Department of Energy
National Nuclear Security Administration
Washington DC 20585

September 14, 2009

DATE: **AUG 13 2009**
REPLY TO:
ATTN OF: CMRR: Fong-2009-07
SUBJECT: Certification Report - Resolution of Defense Nuclear Facilities Safety Board Concerns for the Chemistry and Metallurgy Research Replacement Project

Figure #1 – CMRR Structural Design Process

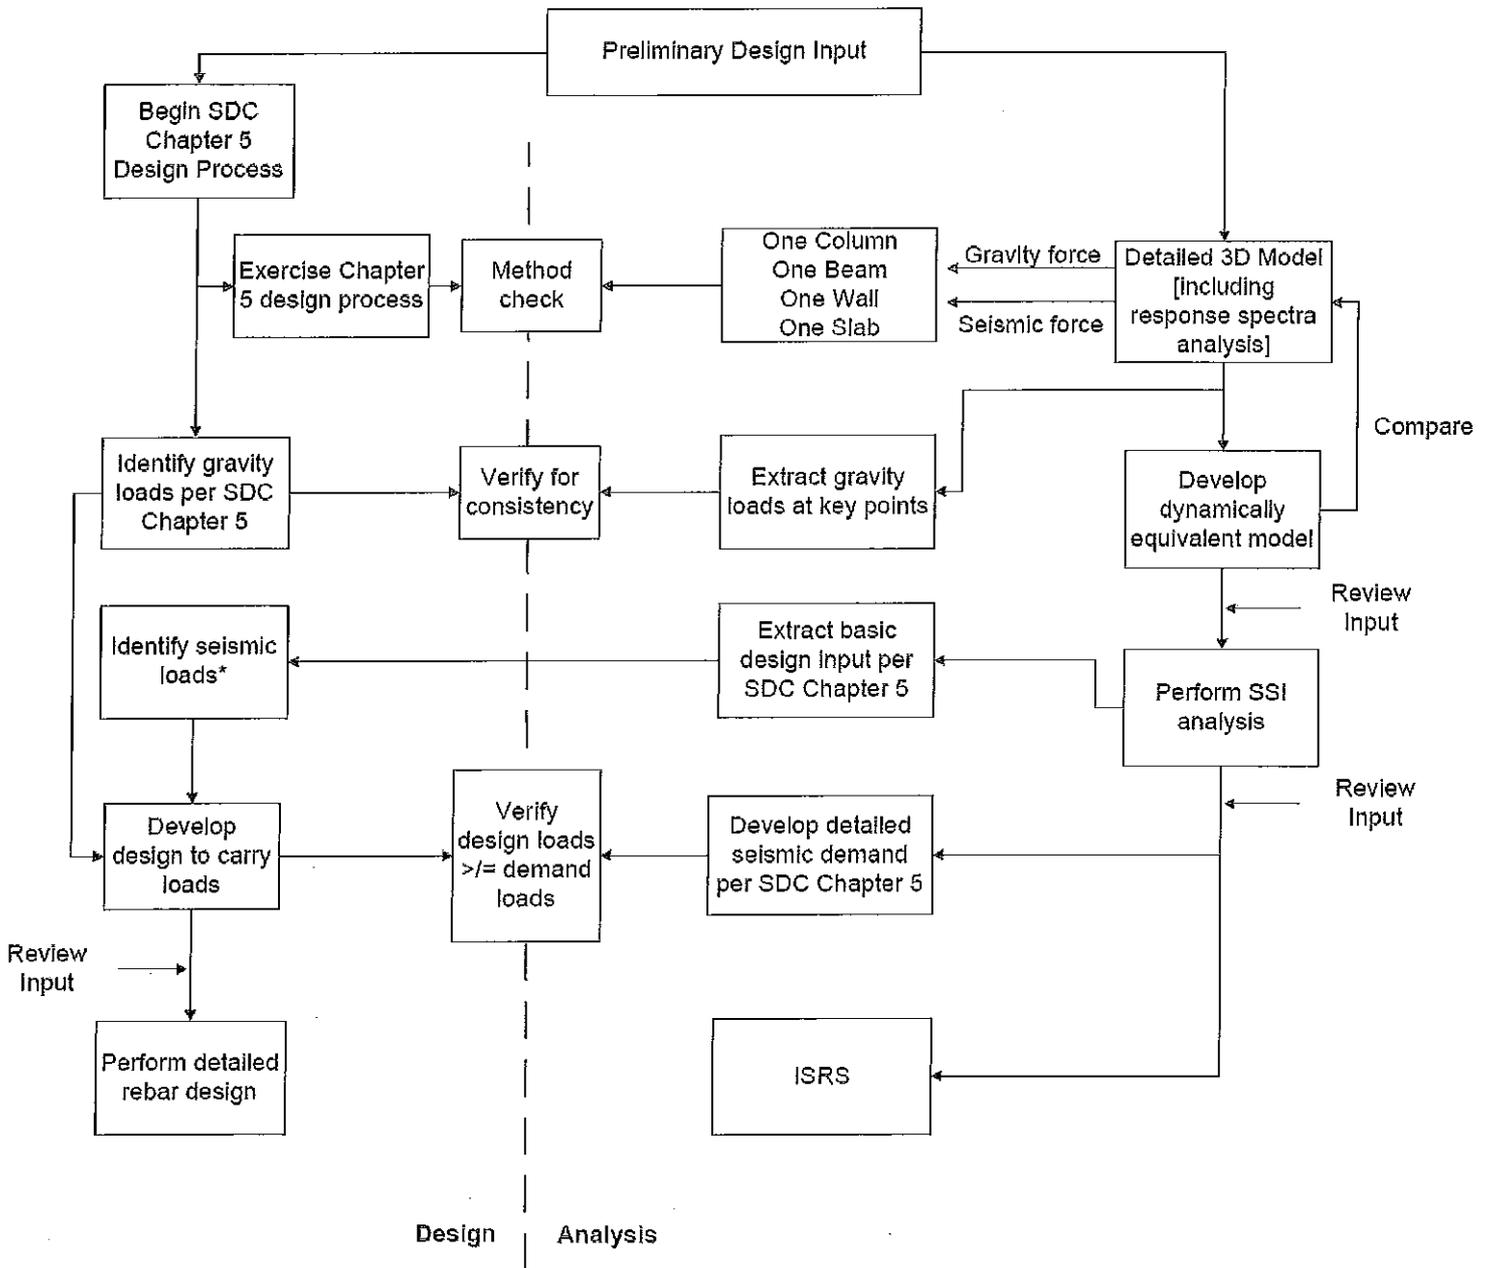
Following the review of documents (Structural Design Criteria, Seismic Design Plan, etc.) the Board suggested the need for a flowchart that shows an integrated analysis and design process. Figure 1 – CMRR Structural Design Process provides a flowchart illustrating the planned approach for the integration of the overall approach for modeling and how it will be used for design, analysis, and verification of the design output. This flowchart is supplemented with a brief summary discussion that provides information related to a number of critical steps identified in the flowchart. The flowchart is described below.

Dynamic responses of the CMRR structure were examined and described in the Structural Behavior Report provided to the DNFSB in June 2009 (Reference 3). As a part of the structural behavior assessment, the response of the building due to higher modes (which includes the response of the mezzanine) was evaluated. A design verification step will be included in the structural design process (see Chapter 5 *Design Criteria for the CMRR Nuclear Facility Structural Design Criteria*, Reference 4, and the flowchart in

Figure #1) which uses SSI section cut forces to assure that the seismic demands are properly incorporated into the design. The SSI results incorporate higher mode effects.

It should be noted that SASSI does not directly produce section cut forces and these demands are produced during post processing. The methodology used during post processing to generate "design forces and moments" on cut sections and its verification will be included in the calculations developed for the verification of the Chapter 5 design process methodology. Based on conversation with the DNFSB staff, the information provided to date, coupled with the commitment to the design process defined in Figure #1, will enable the DNFSB to close Finding #1.
